SERVICE BULLETIN 98

SUBJECT: SLOTTED FLAP HINGE POINT CORRECTIONS

APPLICATION: All Slotted Flap Kits shipped before 1/24/91

FIGURE (1)

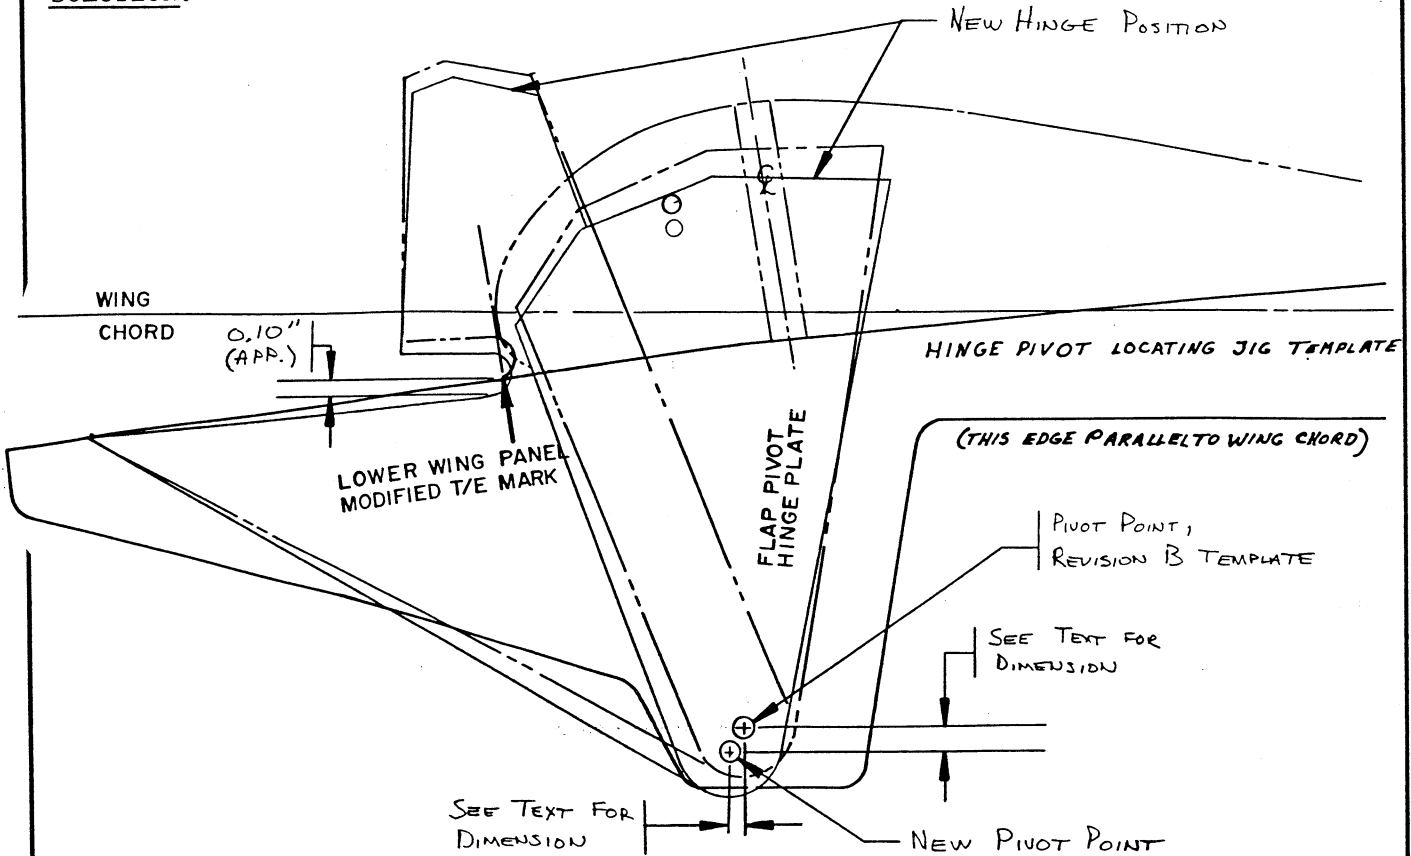
Some builders have experienced problems when using the Revision B Hinge Locating Jig Templates. In some cases, the templates position the flap hinge pivot plates too high so they extend too close to the upper surface of the flaps. This, in turn, causes the rod-end bearing on the actuator rod to protrude above the upper surface of the flap. One cannot simply drill a new hole and trim off the top of the pivot plate, because this changes the lever arm for the actuator.

If you experience a problem with the flap actuator rod-ends protruding above the upper surface of the flap, the only thing you can do is to lower the flap hinge pivot point to get everything back inside the flap without changing the lever arm for the actuator. Try locating new hinge pivot points on the Revision B Hinge Locating Jig Templates, as shown in FIGURE (1) and as described in the following table:

Glasair I, II, and II-S:

- Inboard Hinge: locate the new hinge pivot point .16" below and .13" forward of the existing pivot point shown on the Revision B Hinge Locating Jig Template.
- Outboard Hinge: locate the new hinge pivot point .16" below and .11" forward of the existing pivot point shown on the Revision B Hinge Locating Jig Template.

Glasair III:

- Both Hinges: locate new hinge pivot points .22" below and .08" forward of the existing Revision B Hinge Locating Jig Templates.

To achieve the new hinge point position, rest the leading edge of the wing attach plate against the lower surface of the wing and rotate the aft end down. This will require trimming some material off the notch cut in the attach plate to clear the lower spar cap, and will leave approximately a 0.1" gap between the lower wing skin and the wing attach plate at the modified wing trailing edge. If you trim the wing attach plates, be sure to remove all sharp edges and scratches in the relieved areas. Accomplish this at both the inboard and outboard hinge plates. This modification should be enough to get the flap hinge pivot plate back inside the flap.
